FIRST DRAFT MINUTES

January 17, 2013 Standards Committee Meeting

RE: Minutes for the January 17, 2013 Standards Committee Meeting

REVISION TO SPECIAL PROVISIONS
 805-SGCF-04 SIGNAL HANDHOLE (REVISED DRAFT)

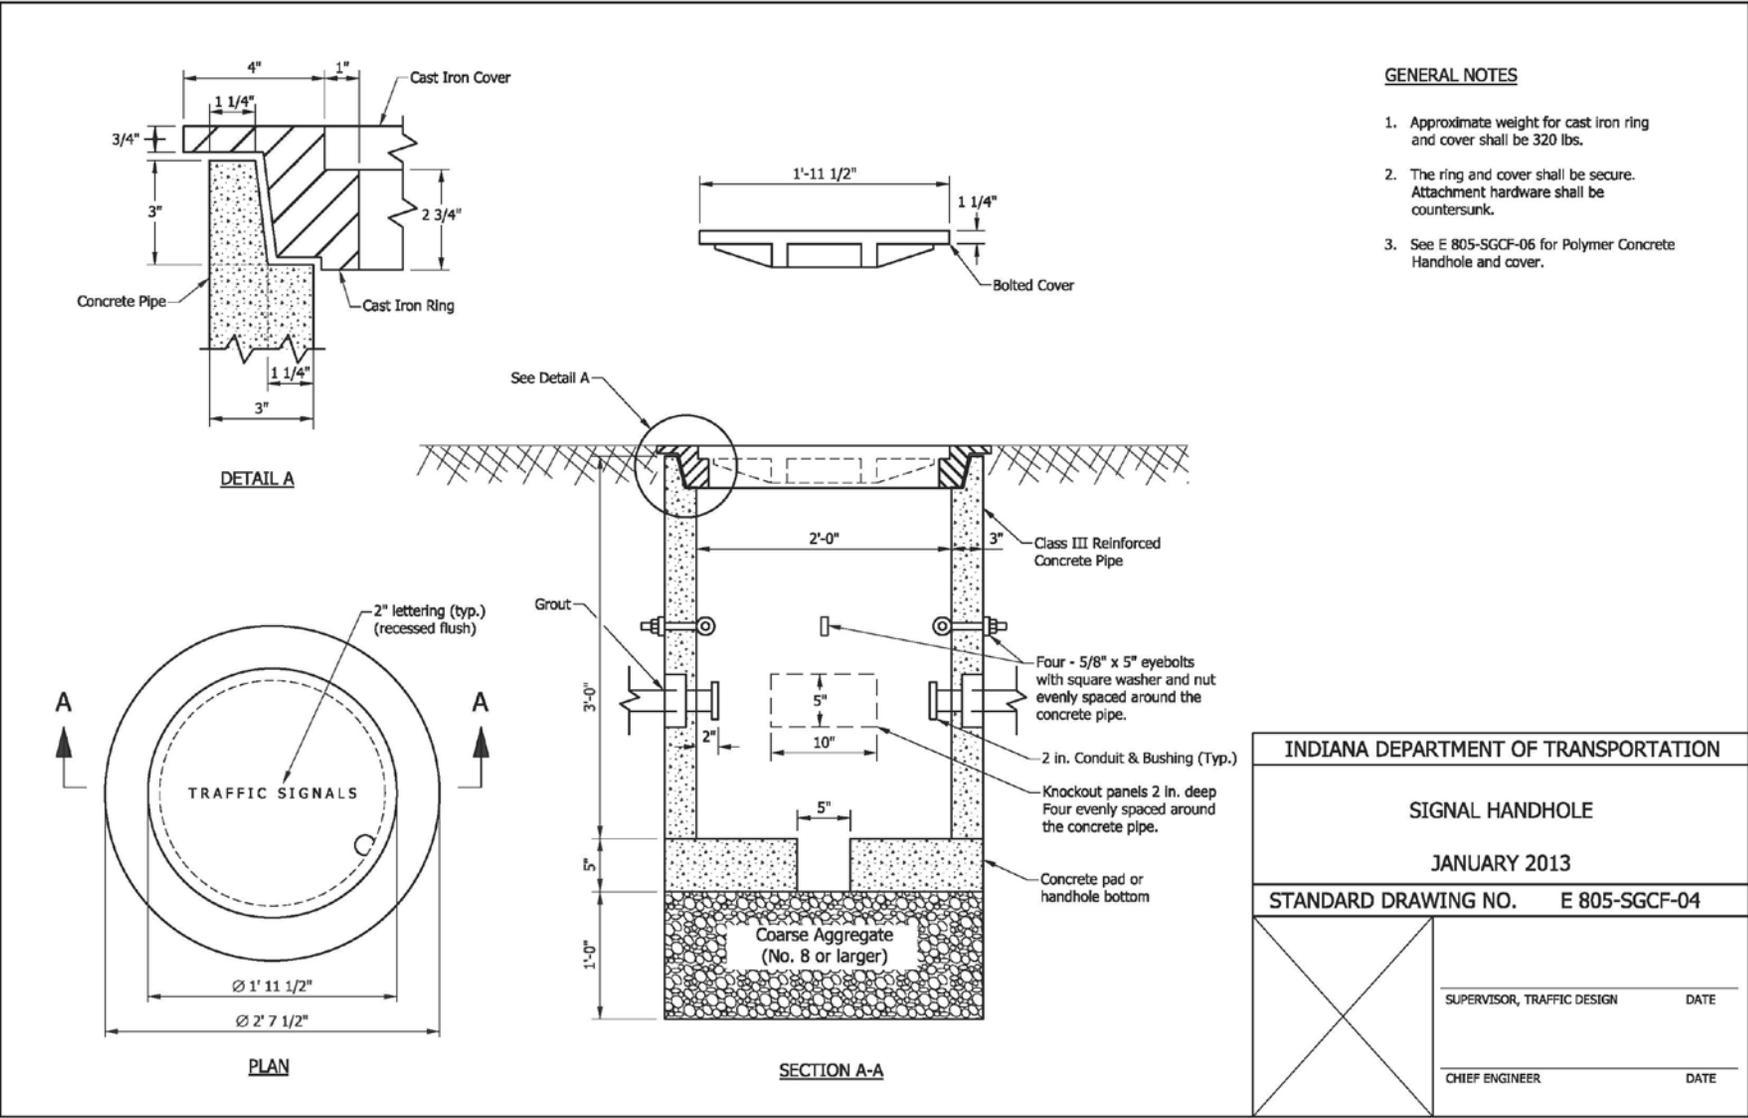
Revise Standard Drawing 805-SGCF-04 for concrete handholes and create a version for polymer concrete handholes. Delete Standard Drawing 805-SGLT-01.

Mr. Boruff will revise the language related to the acceptable hand-hole locations and construction requirements.

PROPOSED NEW 805-SGCF-04A SIGNAL HANDHOLE POLYMER CONCRETE TYPE

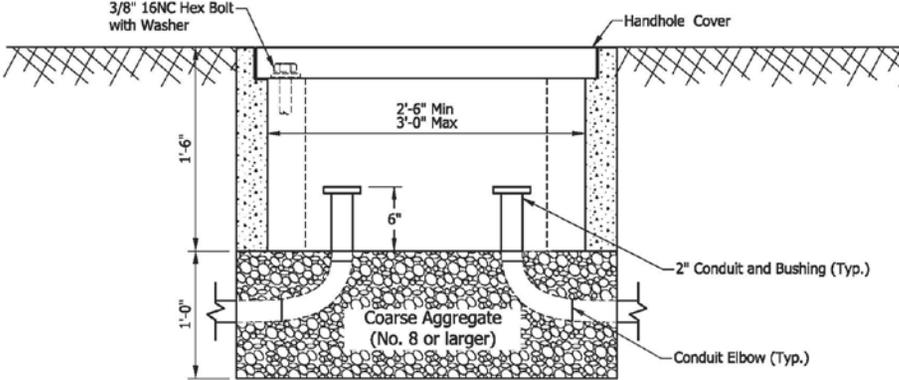
Please note that sections 805.02, 805.16 and 922.17 of the INDOT *Standard Specifications* are being revised and Standard Drawing to allow the use of polymer concrete handholes.

EXISTING 805-SGLT-01 LOOP TAGGING SYSTEM (PROPOSED TO DELETE)

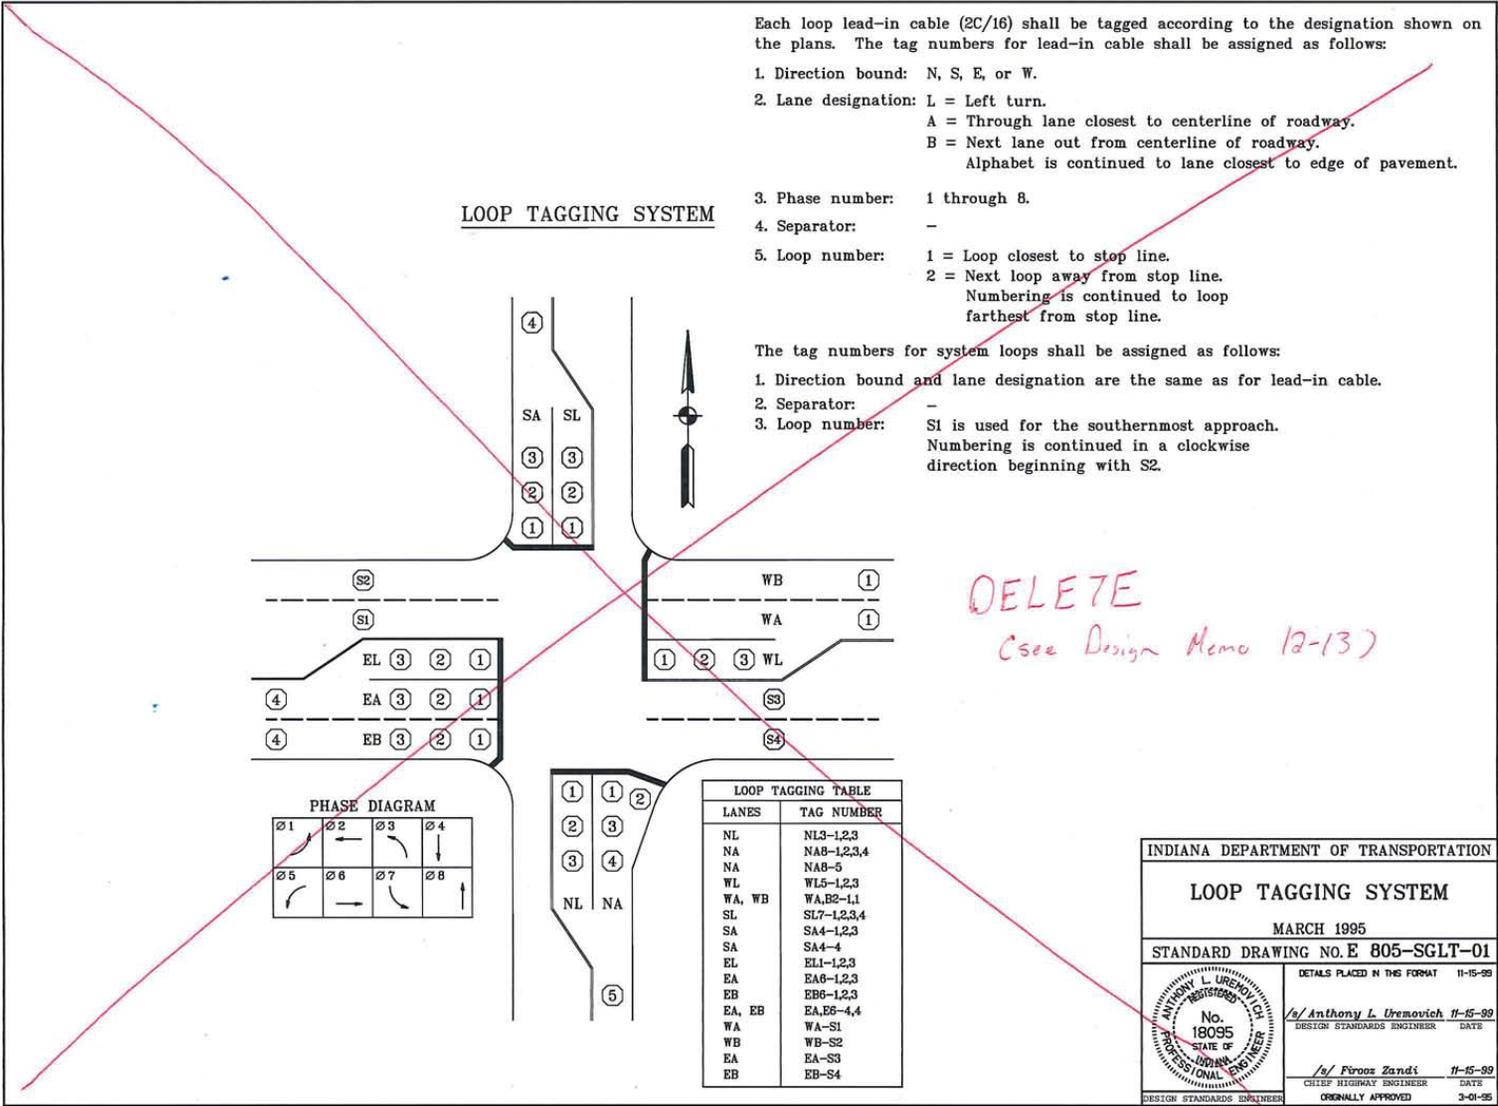
Standard Drawing 805-SGLT-01 detailing the loop tagging table is not accurate and is redundant after Design Memo 12-13.
